DATE: AUGUST 24, 2026

ADDENDUM NO.: 2

PROJECT: A NEW BRANCH OFFICE
1208 Texas Research Parkway (SH211)
[211 and Potranco]
(Bexar County)
San Antonio, Texas 78245

SSI – 1 (Addendum-2)

A9.1

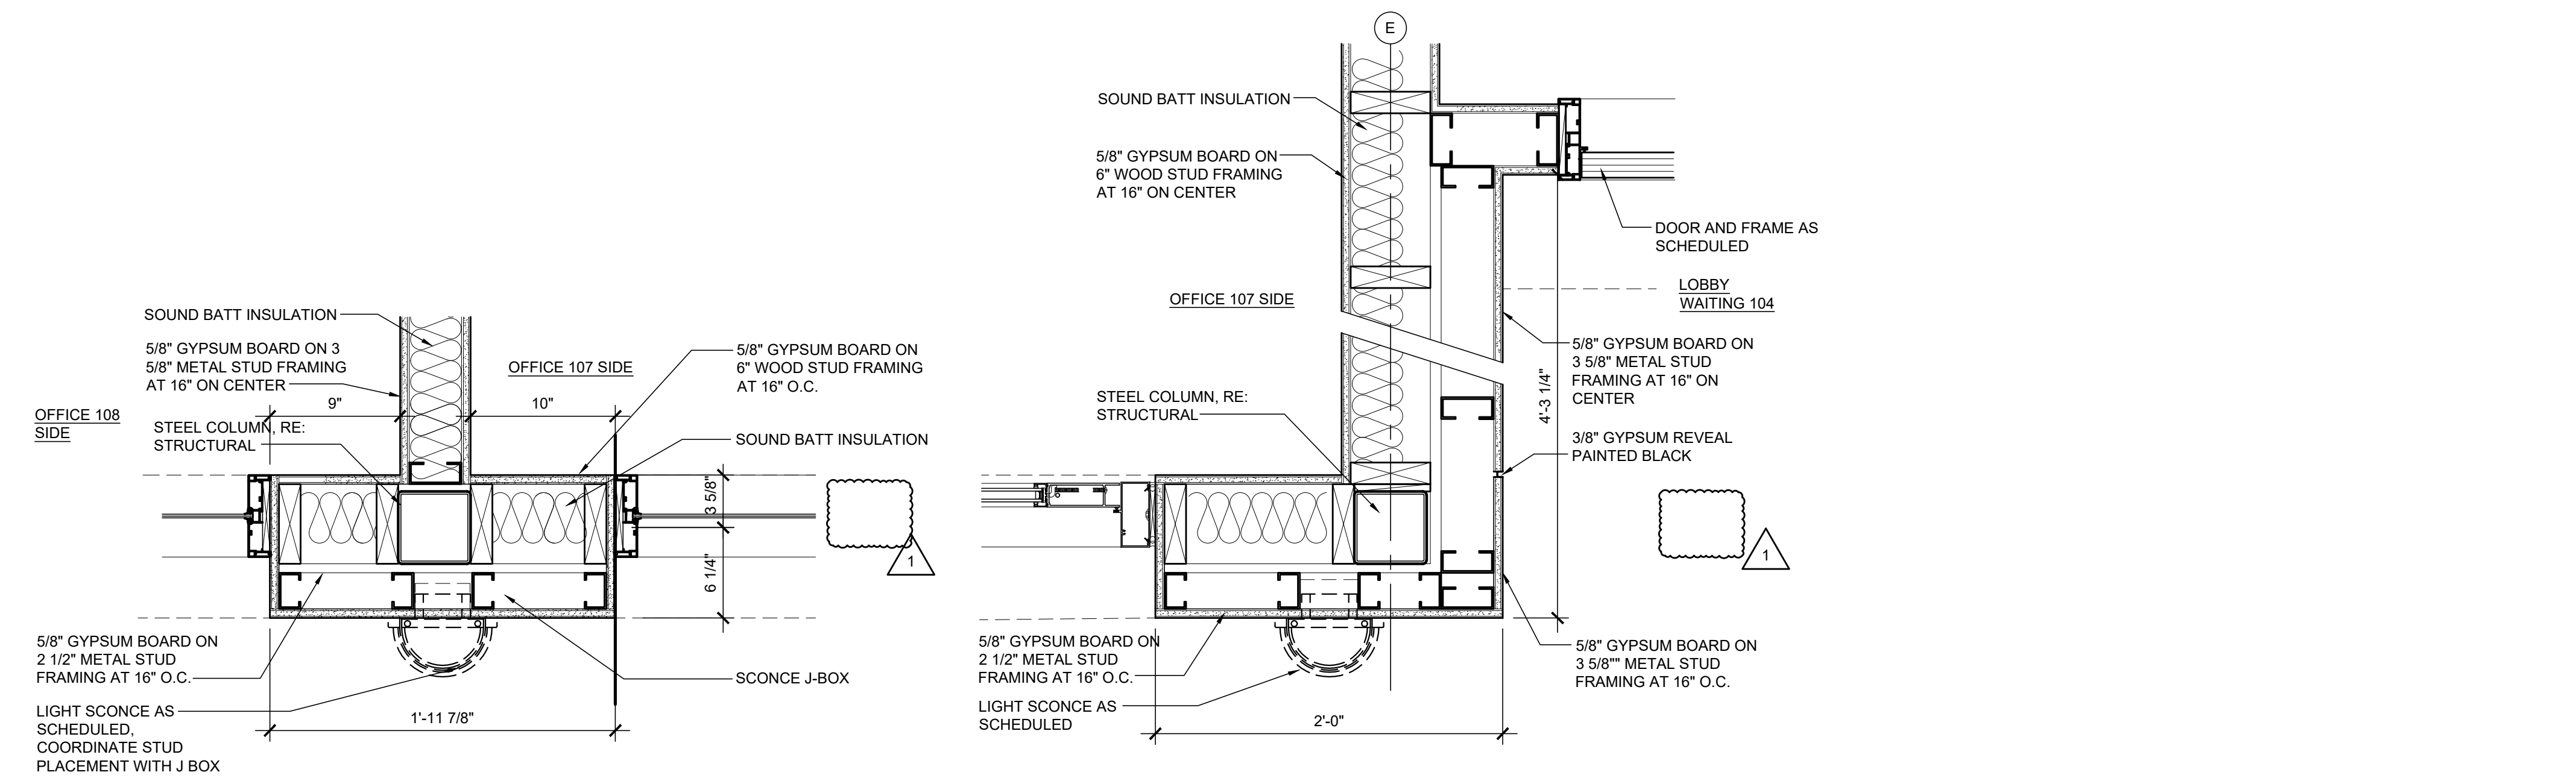
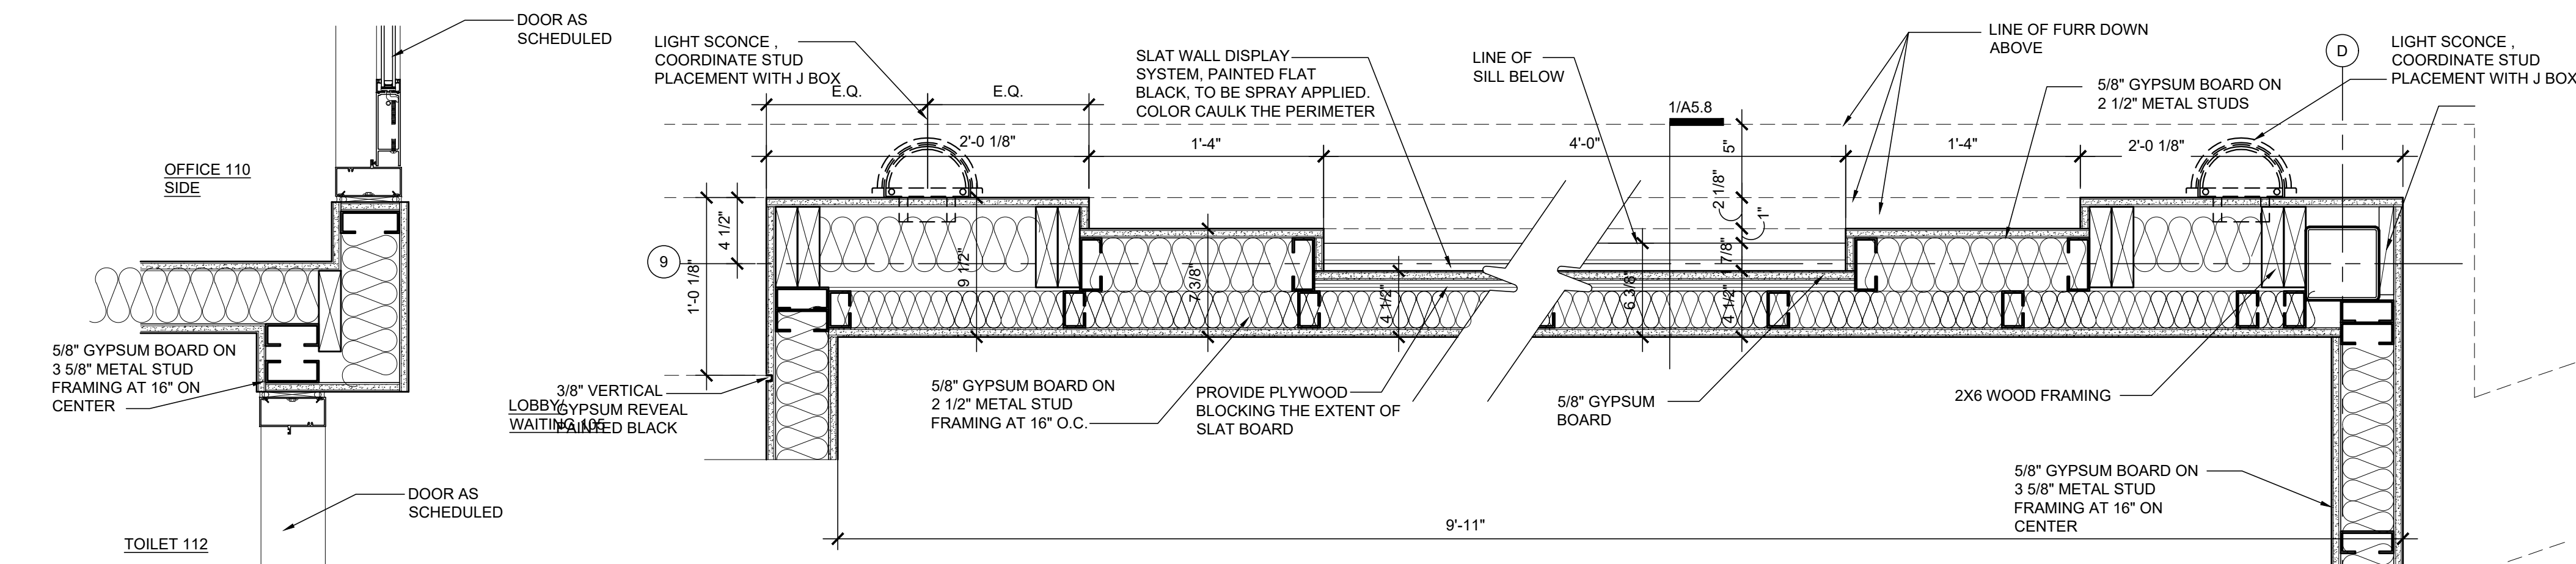
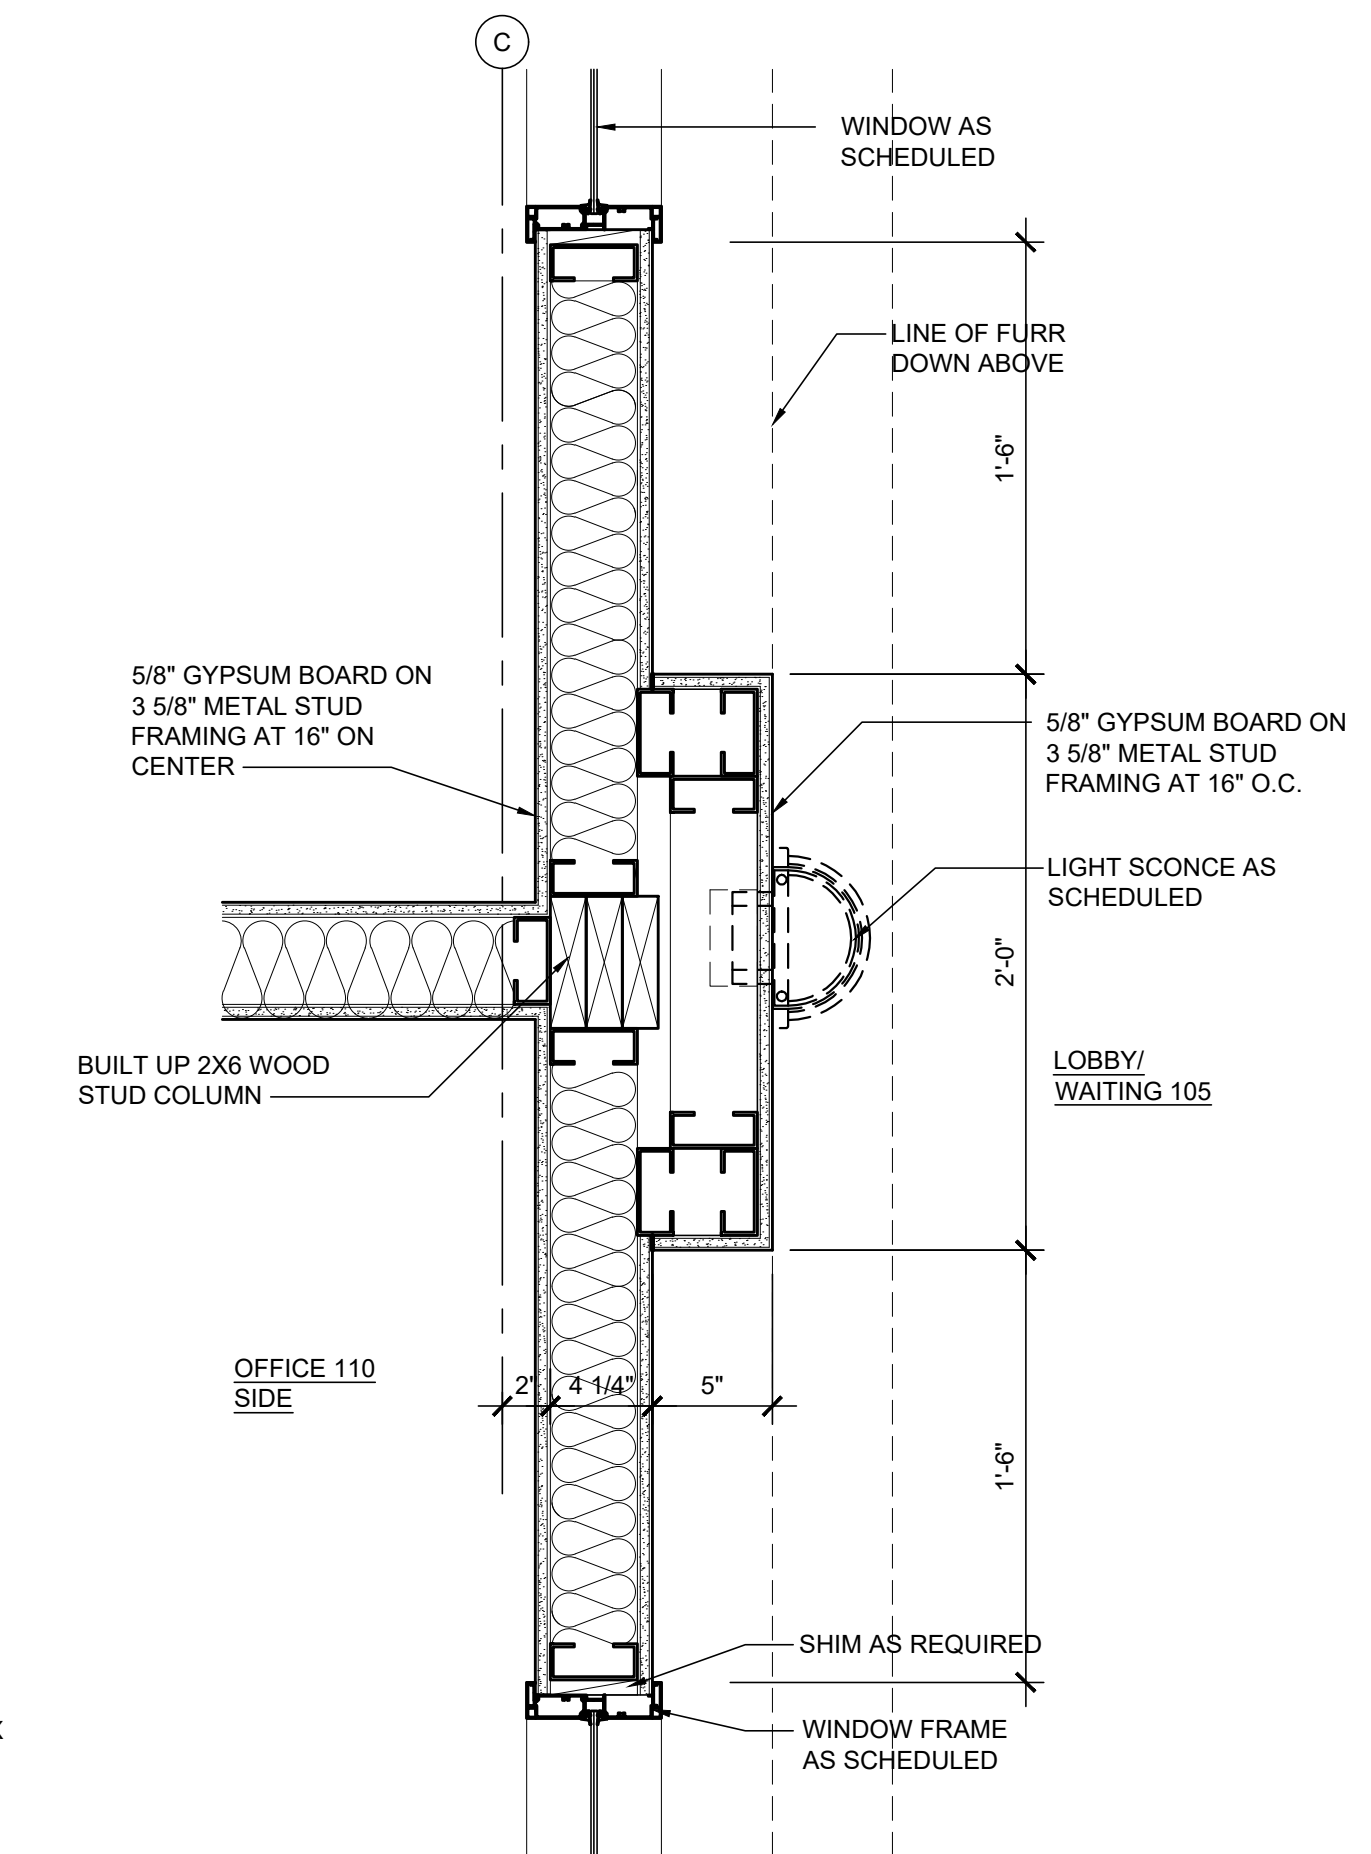
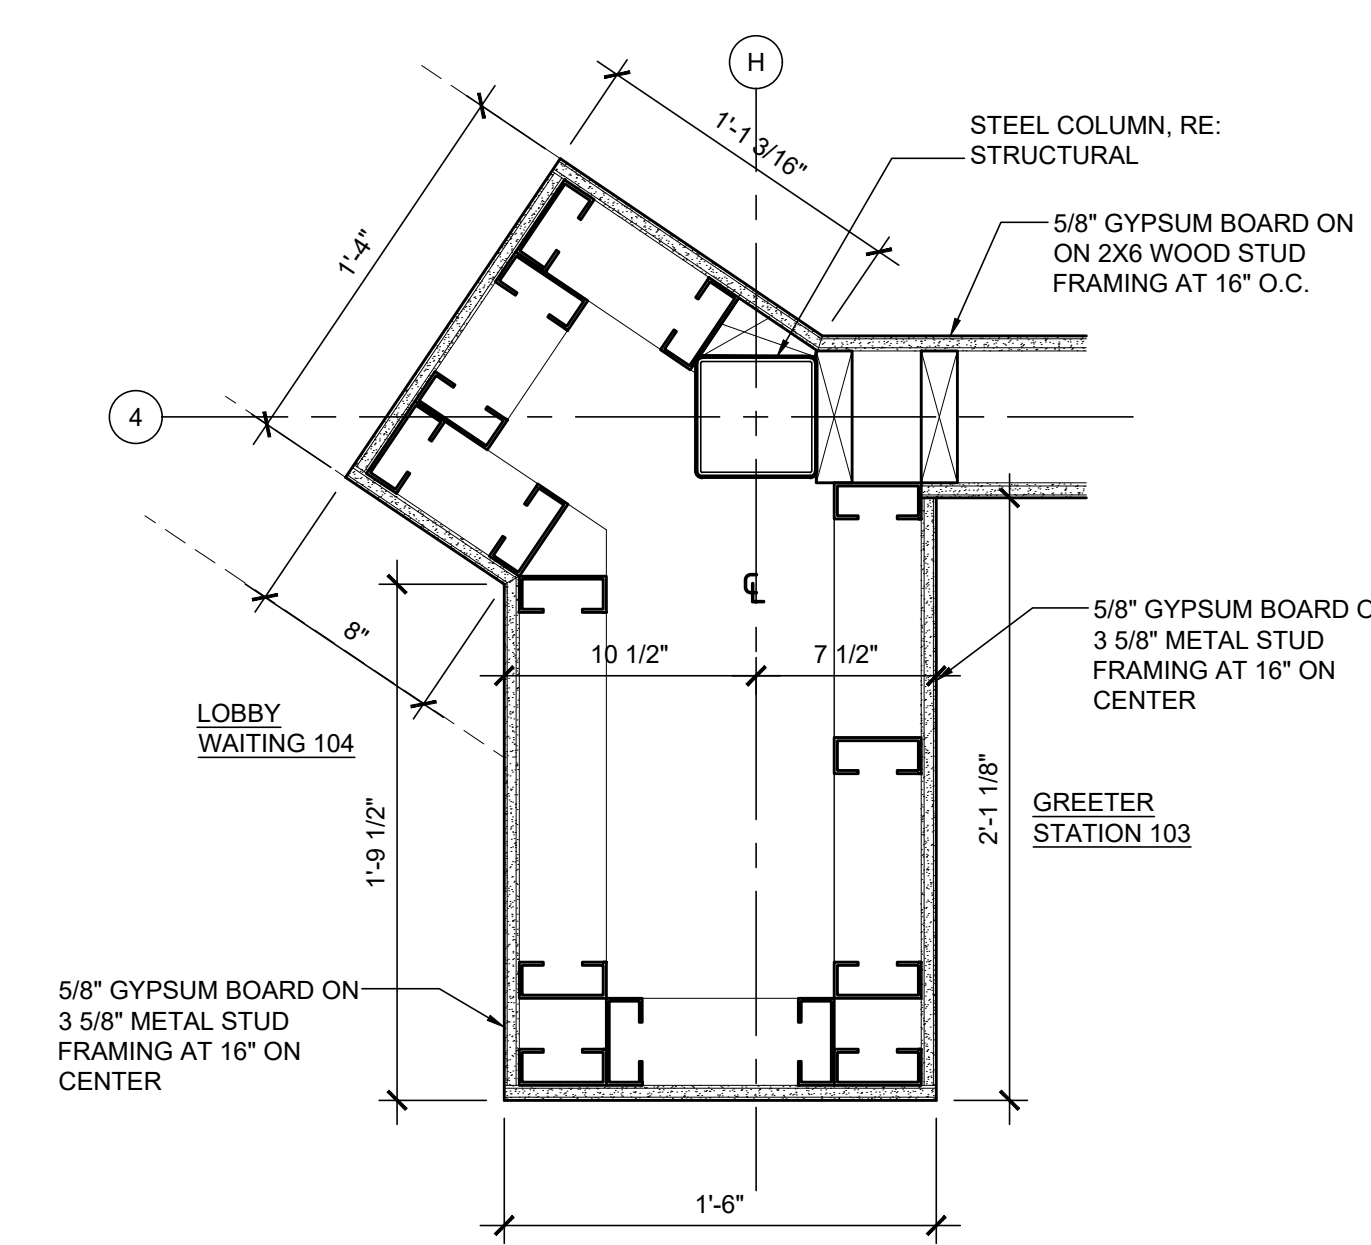
Sheet A9.1 - Omitted grid line 5

JOB NO:	2537
DATE:	3-27-26
DRAWN BY:	MDJ
CHECKED BY:	FFL
SHEET	A10.3

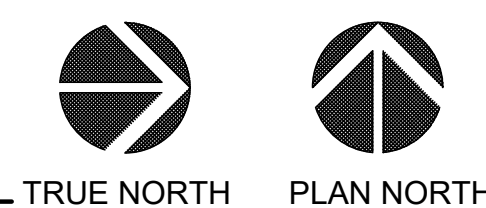
Sheet A10.3 – Added mini blinds to greeter station on equipment plan.

ANSWER: Office 110 is the only interior window to receive mini blinds. Mini blinds are also to be installed at office 116 exterior window and greeter station window. Refer to equipment plan for location of roller shades on office exterior windows. See Exhibit A for Clouded revision on A6.1 and A10.3.
